# Access Compliance Report Public Rights-of-Way (Curb Ramps)

Main Street: S\_WINTHROPE\_ST Cross Street: FAIRHAVEN\_AVE Location: NE

ADA ID: RPRK211006174552 Ramp Type: Type 1 - Perpendicular Diagonal Initial Pass/Fail: Pass Overall Compliance: No Severity Score: 10

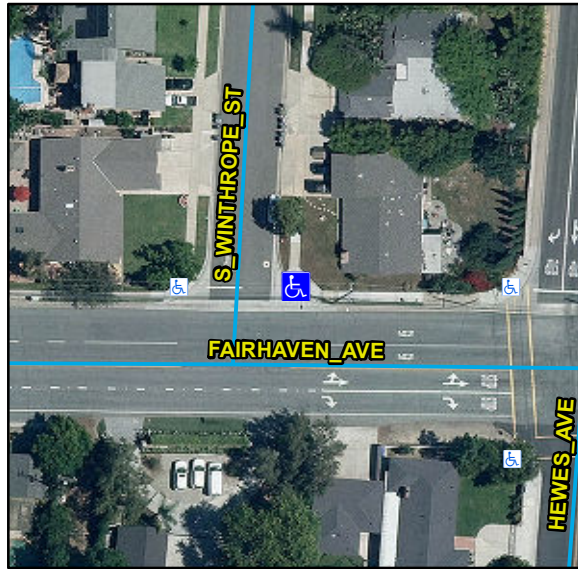
| Compliance | Description                           | Data | Compliance | Description                   | Data   |
|------------|---------------------------------------|------|------------|-------------------------------|--------|
| No         | Landing Width (in)                    | N/A  | N/A        | Flare Slope RT (%)            | 8.4    |
| No         | Landing Run Slope (%)                 | N/A  | N/A        | Flare Traversable RT          | No     |
| No         | Landing Cross Slope (%)               | N/A  | Yes        | DWS Provided                  | Yes    |
| Yes        | Gutter Ponding                        | No   | No         | Curb Slope                    | 18.8   |
| No         | Gutter Cross Slope (%)                | 4.7  |            |                               |        |

Remove & Replace Curb Ramp With Two New Directional Ramps or Equivalent. Remove & Replace Gutter.
